Refs 2022/93234 LBC museum, 2022/93235 LBC Queensgate Market & art gallery & 2022/93248 Piazza

I wish to give my general support to the application and want to comment on some issues.

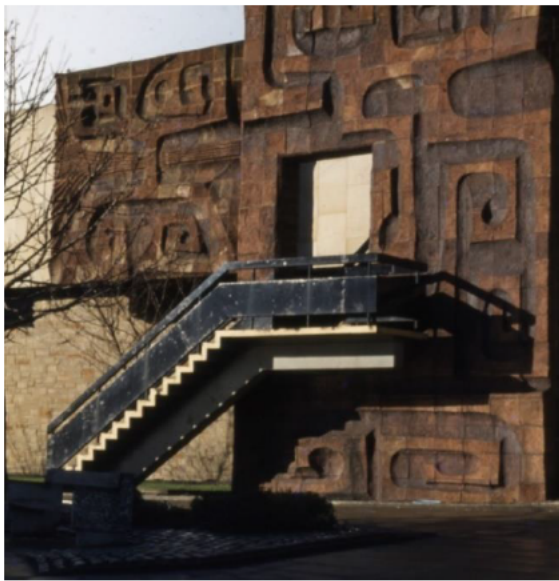
1. The application seems to disregard the significance of the grade II listed staircase through ceramic panel 10 onto Queensgate.

The form and geometry of the 1970 staircase was extraordinary with an apparently unsupported raw concrete stringer beam, pale Ballidon limestone with a glistening quartz-like material concrete riser and tread ends with occasional but regular ballusters bearing black profiles.

The staircase and extended quarter landing were designed and built as 'floating' cranked hidden spine-stringer supporting flights of steps with 'floating' balustrading and handrail. Achieved without newel posts or many spindles and at first sight not meeting the walls. The spindles are minimal without compromising the structure and the handrail had hidden supports to masonry.

The continuous tread and riser ends exhibit a pale zig-zag up the staircase. The balustrading and handrail 'floating above'.

This highly sculptural form is unusual and spectacular – not just a utilitarian staircase that has carried many hundreds of people a day for 50 years.

Later replacement parts disregarded the visual significance of the staircase and contrast to the panel. Some really clumsy work was done. I was consulted in 2016-8. And later much of that was undone during renewal work during the pandemic but not all.

The proposed alterations are described in manner I don't understand but disappointing as the 1970 design is disregarded. See 2022-93235_Plan+General_954570 "Note 16. Existing stairs with new metal balustrade with vertical flats".

See also 2022-93235_Plan+General_954577 3.5.3 Stair through panel 10 onto Queensgate

I have been unable to find any justification for this work in the application to a listed heritage asset.

I hope restoration work can be conditioned.
